DATE: 8-11-17

APPLIES TO: This service bulletin applies to 2017 – 2018 model year K2 model motor home chassis equipped with an Independent Front Suspension supplied by Reyco Granning built between January 17, 2016 and March 16, 2017.

CONDITION: Some bleeder assemblies may leak power steering fluid.

CORRECTION: Apply thread sealant.

FIG. 2-2

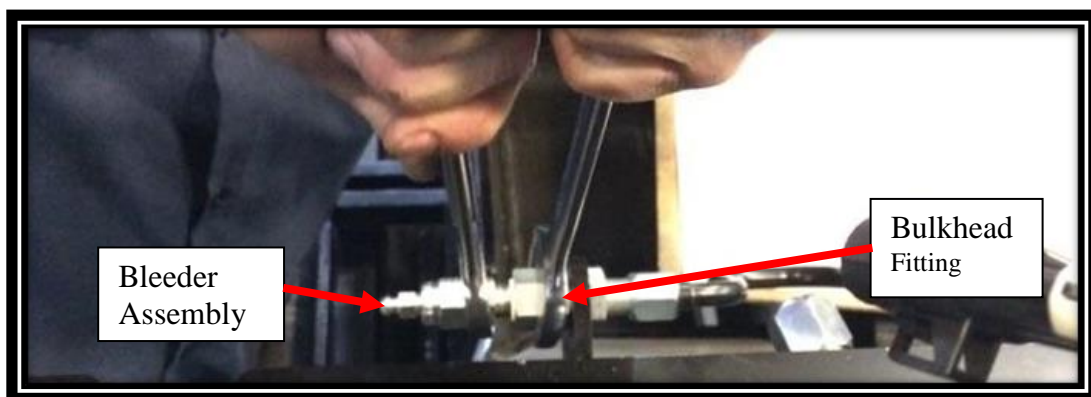
1. Place a drain pan under bleeder assembly.
2. Remove bleeder assembly from bulkhead fitting. Refer to FIG. 2-2.

FIG. 3-2

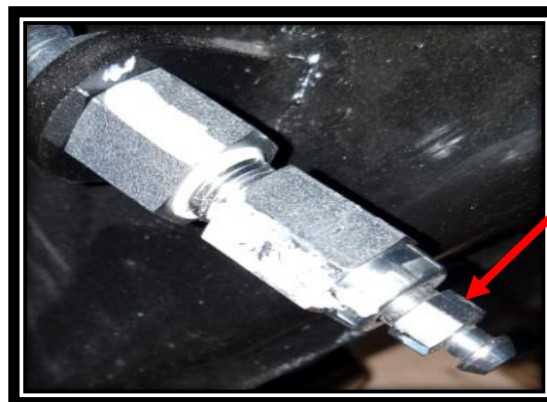
5. Install taped bleeder into bulkhead fitting finger tight.
6. With 11/16" and 13/16" wrenches tighten bleeder 2-3 additional turns.
7. Torque bleeder with 3/8" socket to 35-40 lbf-in. Refer to FIG. 3-2.
